## DESIGN REVIEW BOARD MARCH 17, 2017

ALPHARETTA CITY HALL  
COUNCIL CHAMBERS  
2 PARK PLAZA  
8:30 AM

**2. 09:15 - 09:45 DRB170005 Zyka 3800 Brookside Pkwy**  
review landscape and additional details on other plans

**7. 11:20 - 11:45 DRB 160081 Courtyard by Marriott 11700 Amberpark Dr**  
review corner feature and landscape

WATER FEATURE & SCULPTURE PLAN & ELEVATION

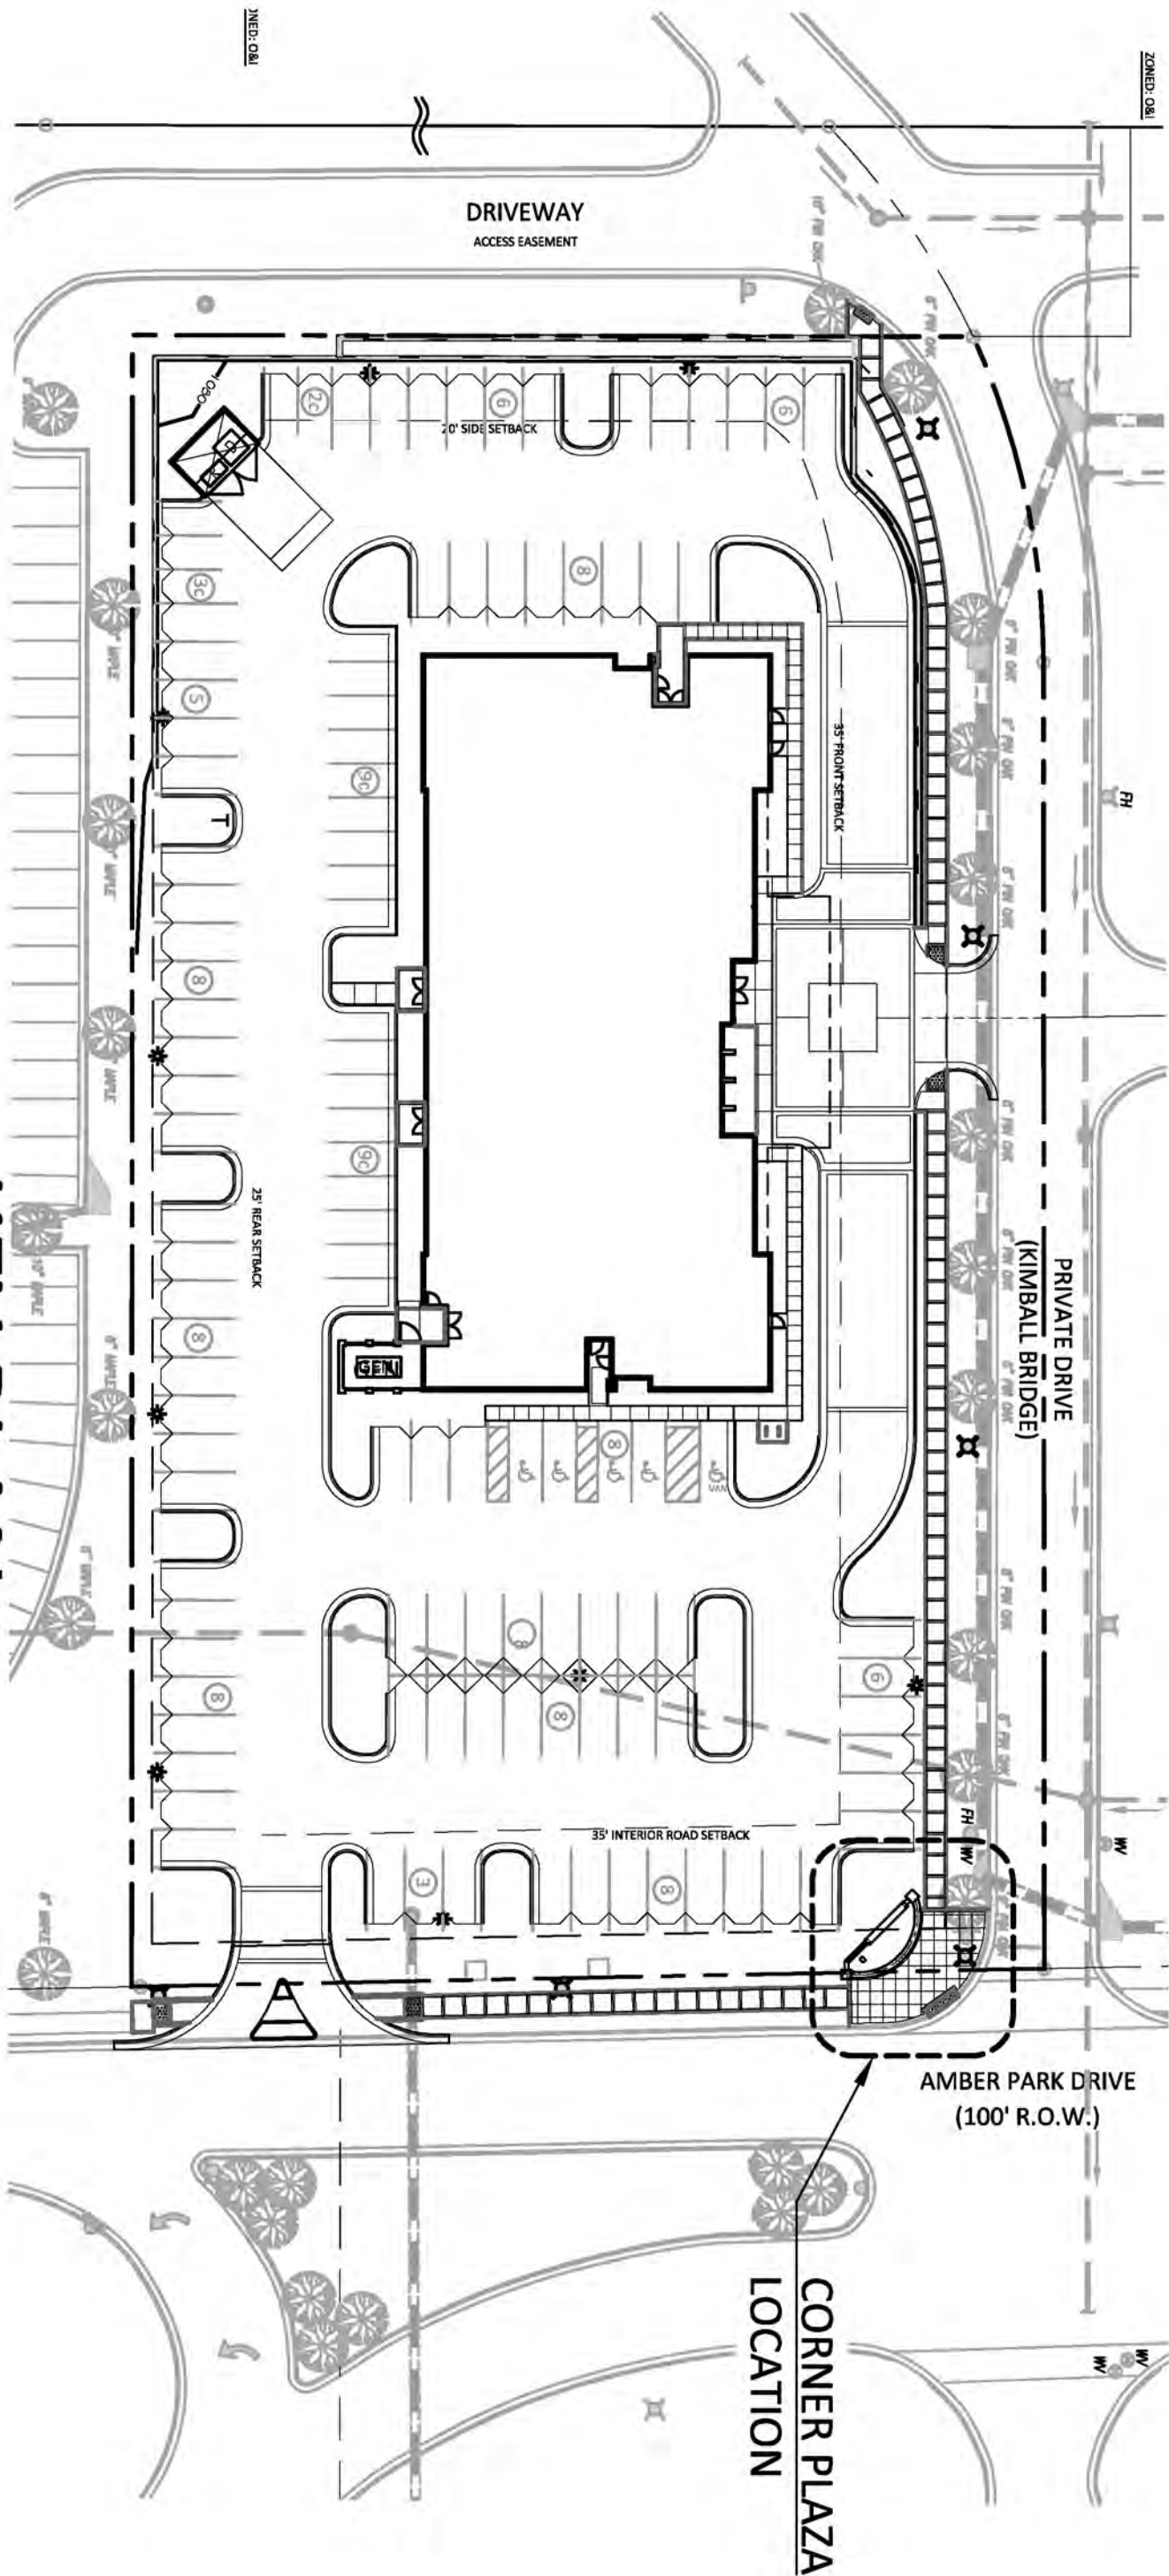
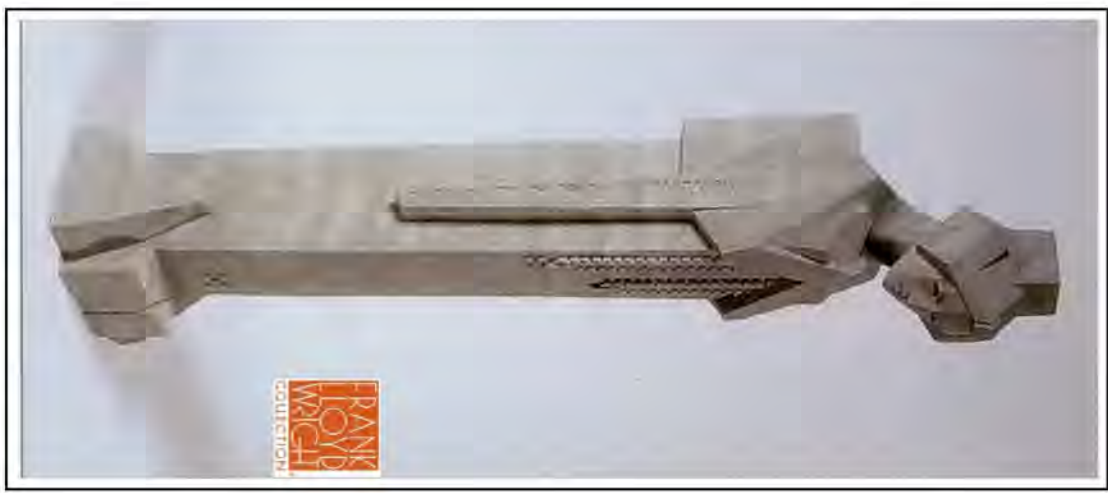
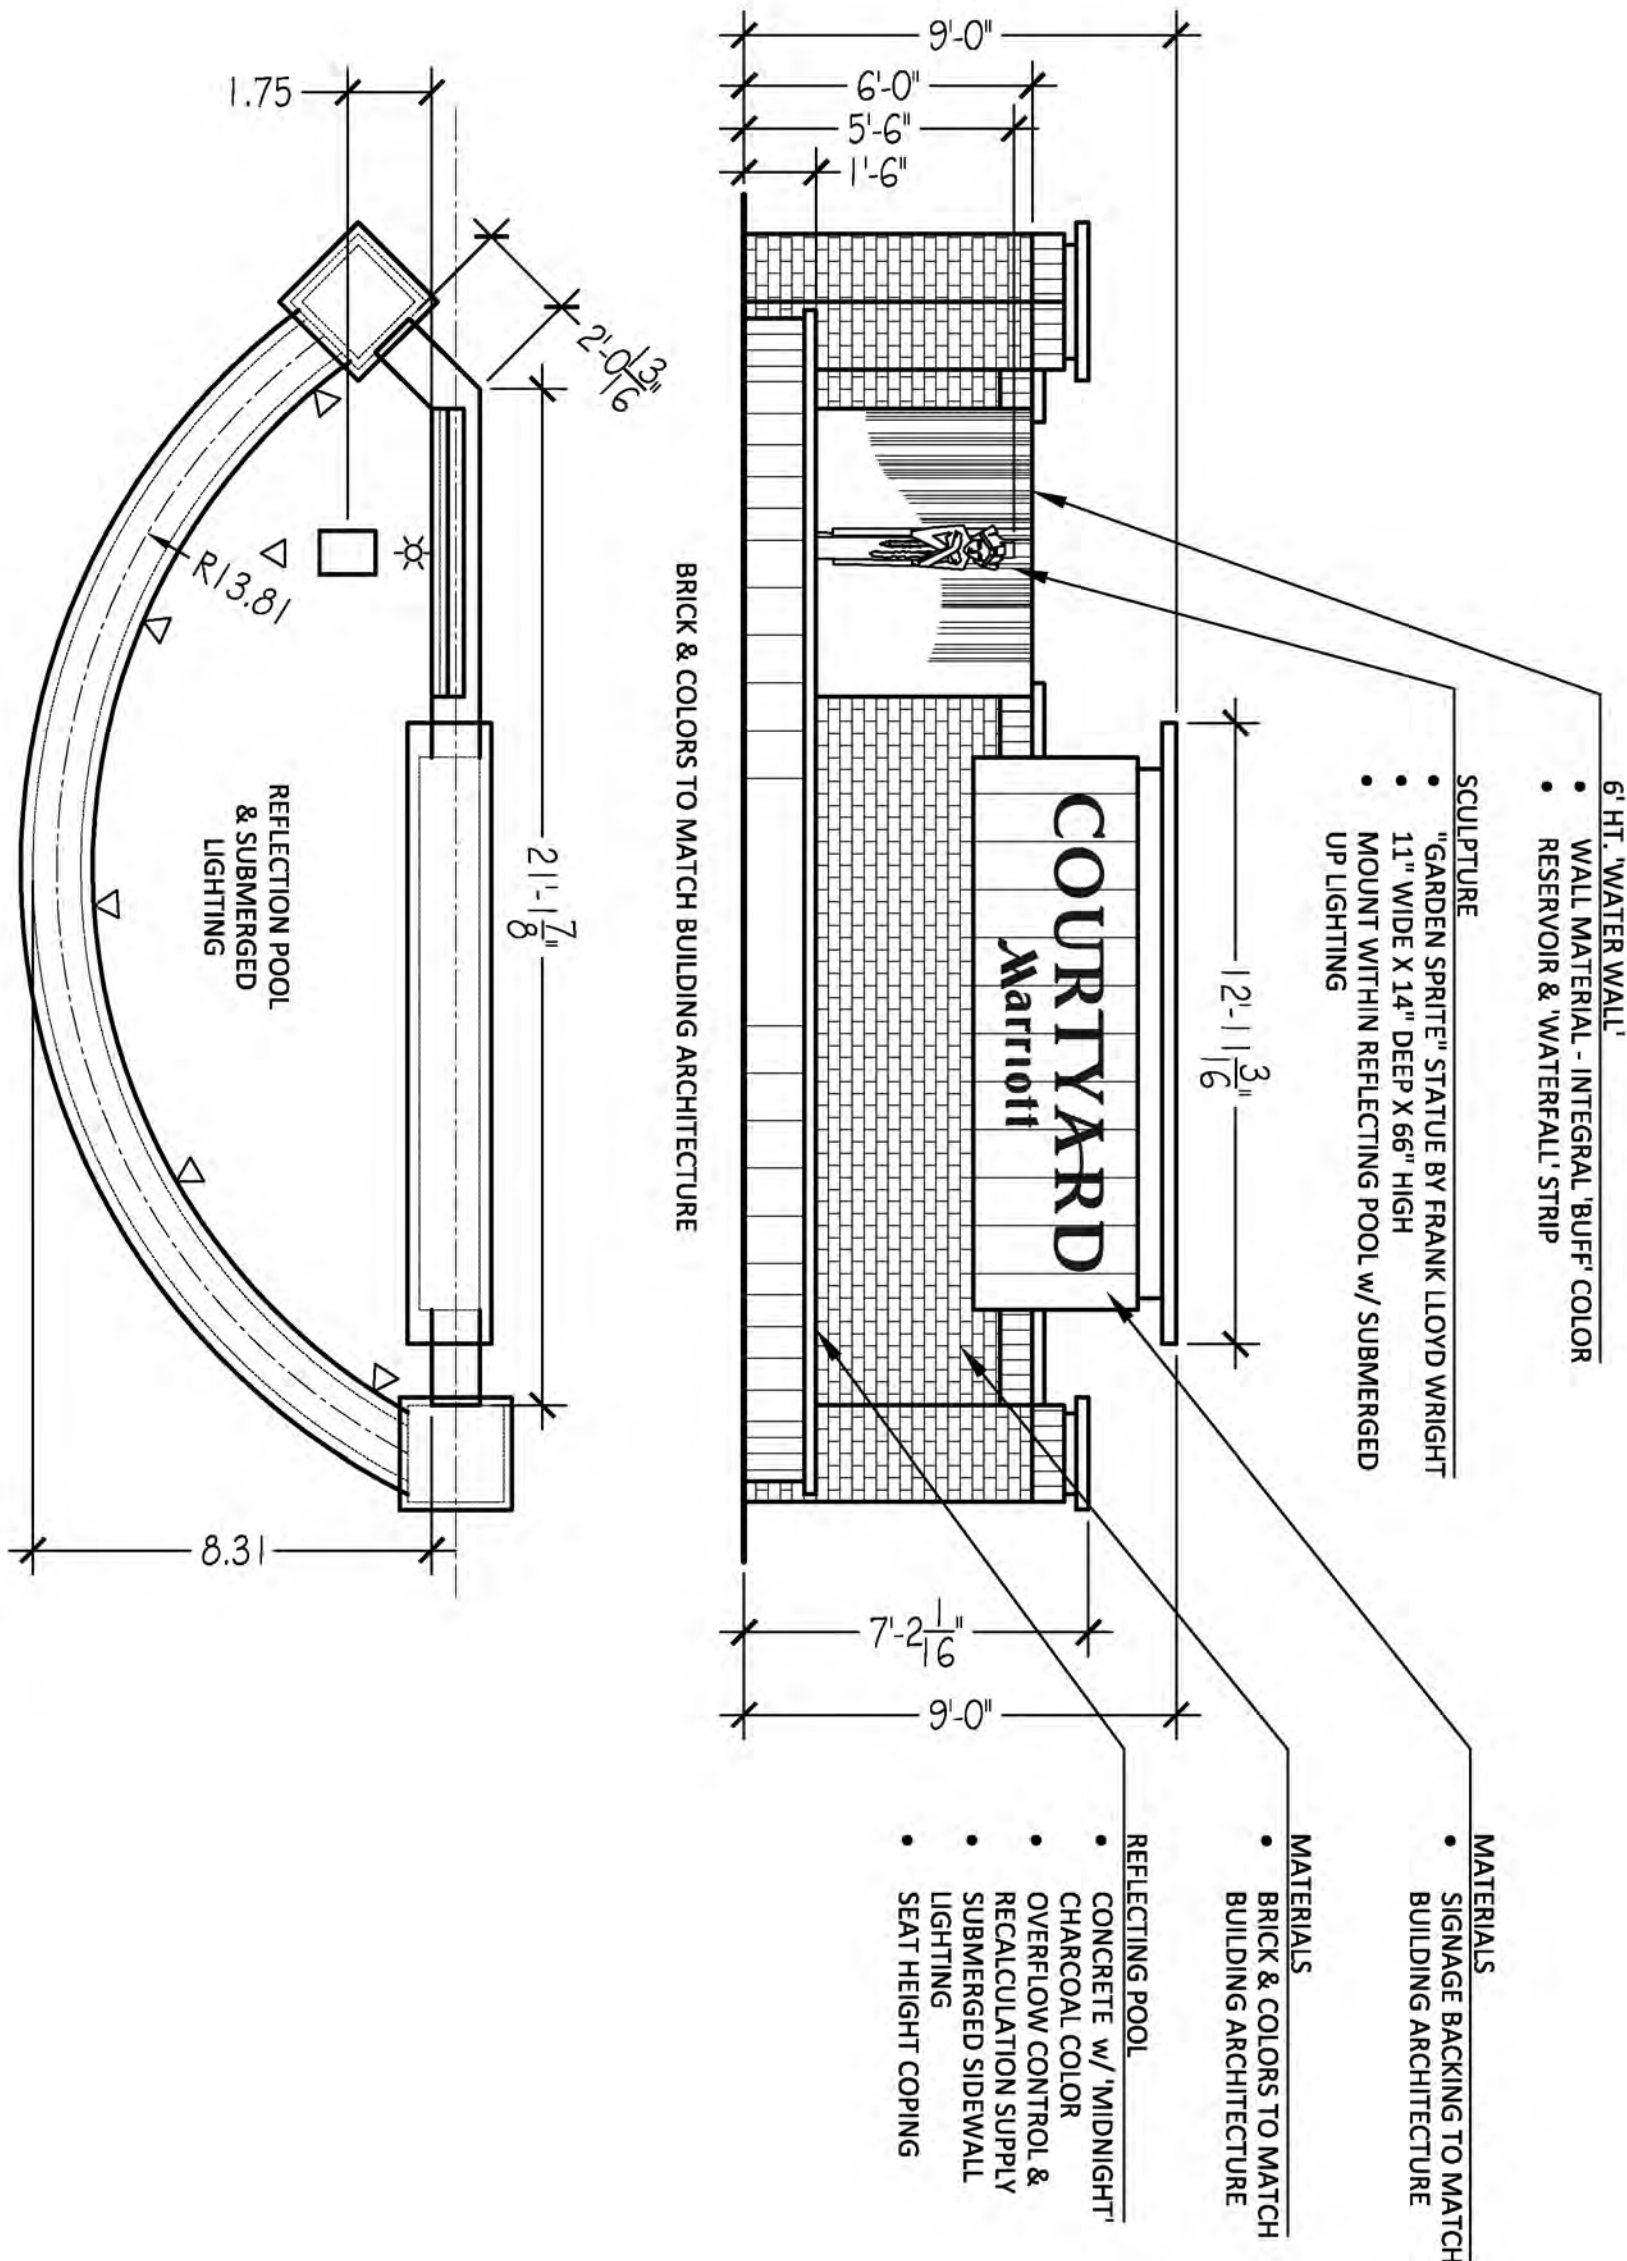
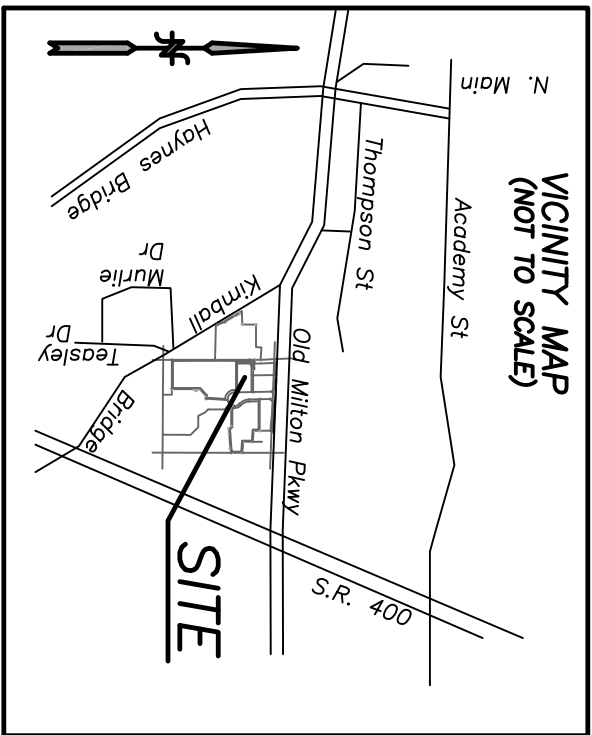
8. Sidewalks shall be installed on the north and east of the property at least 6” wide.
  9. Provide one (1) electric vehicle charging station.
  10. A water feature with a statue shall be installed on the corner of Amber Park Drive and private road or along private road to be approved by DRB.
